SERVICE No. 423 BULLETIN

Piper Aircraft Corporation

Subject: Propeller Electric De-Icer Solenoid Replacement

Models Affected: PA-31P Navajo

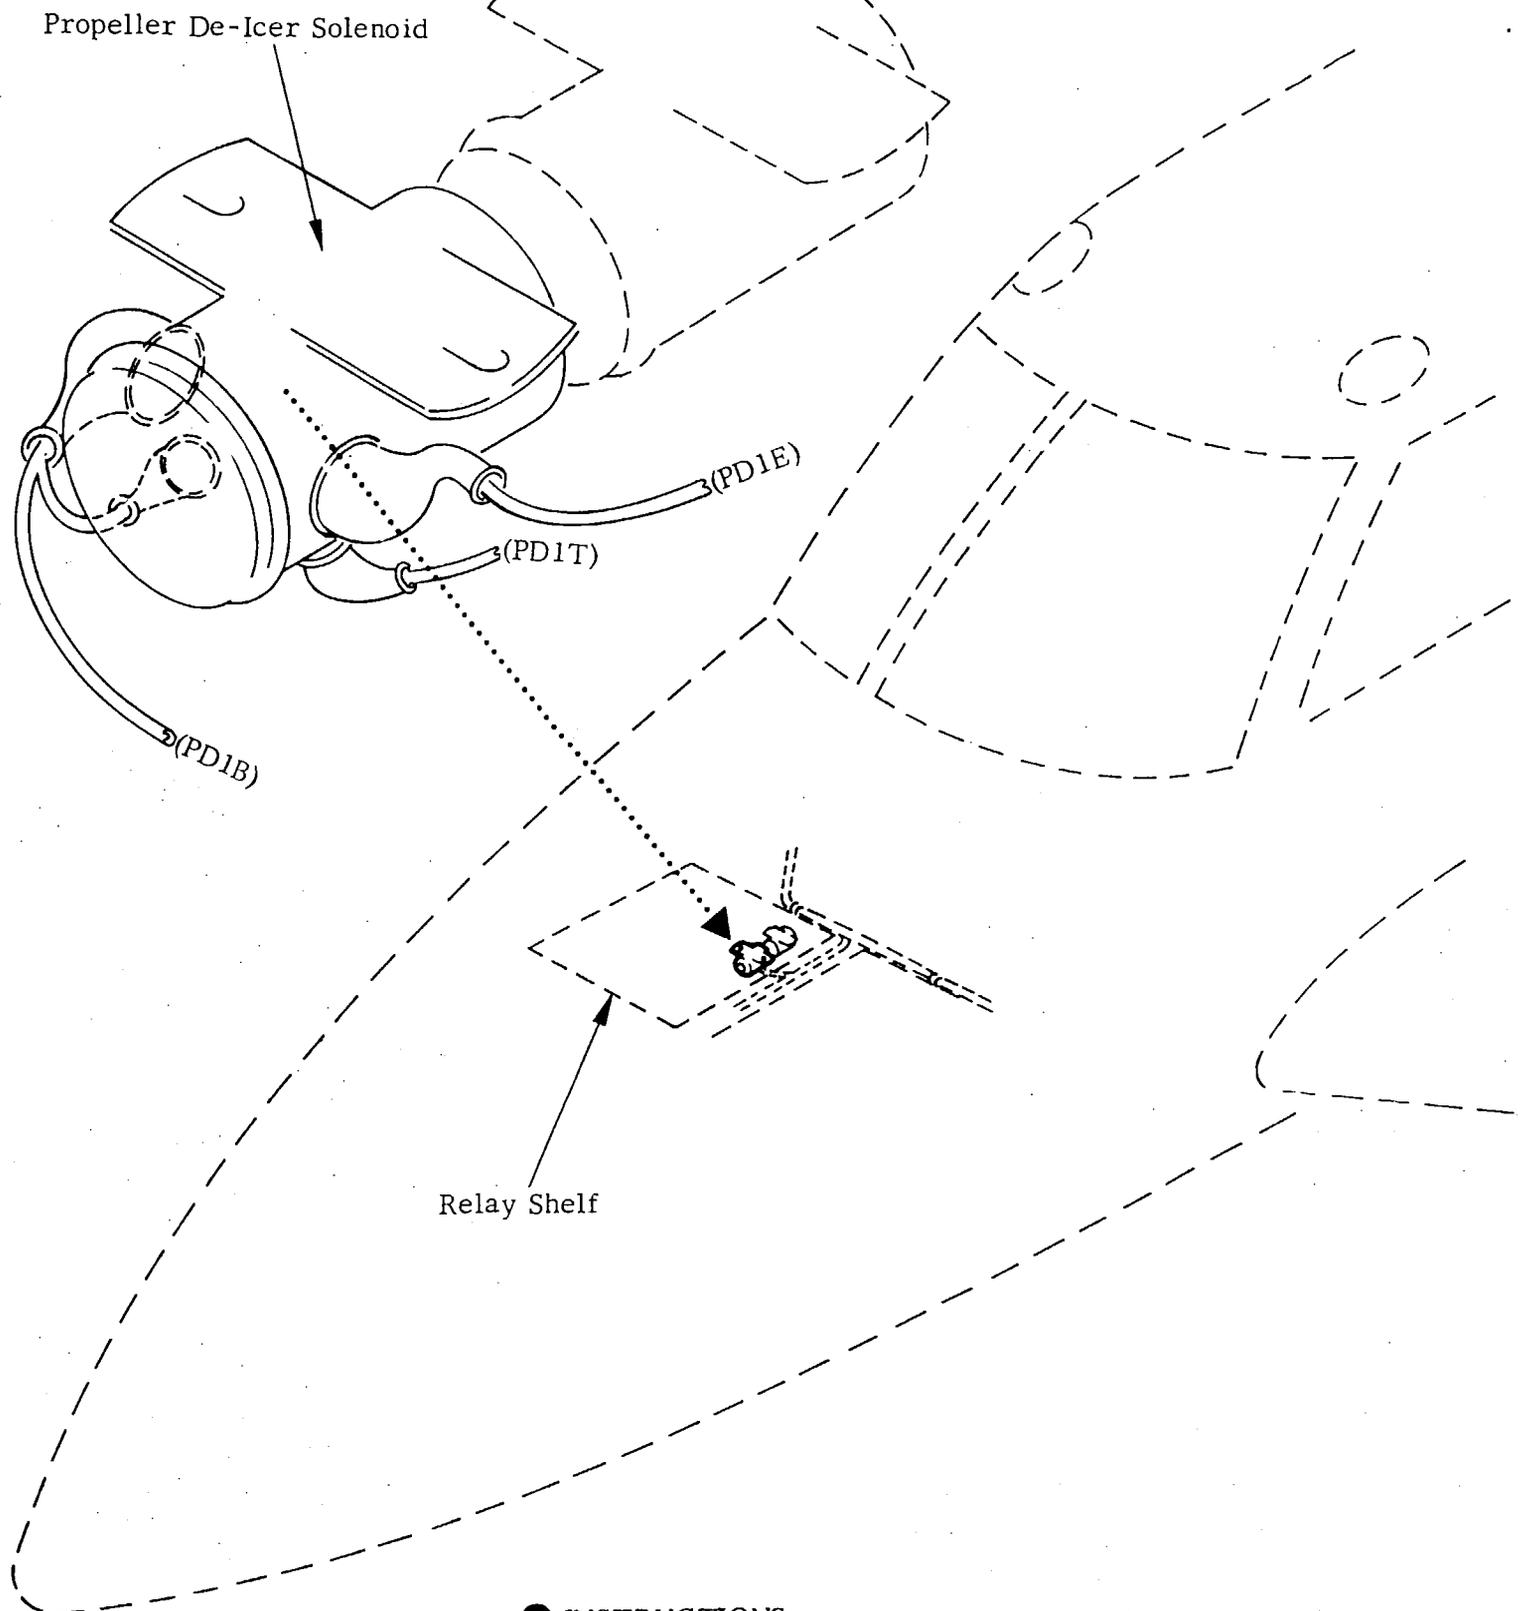
Purpose: To announce a propeller electric de-icer system refinement consisting of a change from the existing "intermittent" type solenoid to a "continuous operation" type solenoid. The new "continuous operation" solenoid is designed to provide increased reliability and extended service life.

1. Solenoid replacement -- refer to attached sketch/instruction data for solenoid replacement instructions.
2. Subsequent to solenoid replacement, check operation of the propeller de-icer system in accordance with the Pressurized Navajo Service Manual, Section XIV, Accessories and Utilities, De-Icer System Operational Check.
3. Make appropriate log book entry.

1. Remove access panel from right side of forward fuselage to gain access to the relay shelf.
2. Disconnect wires from existing propeller de-icer solenoid and remove solenoid.
3. Install new solenoid P/N 26898-05 and reconnect wires as shown.
4. Reinstall access panel.
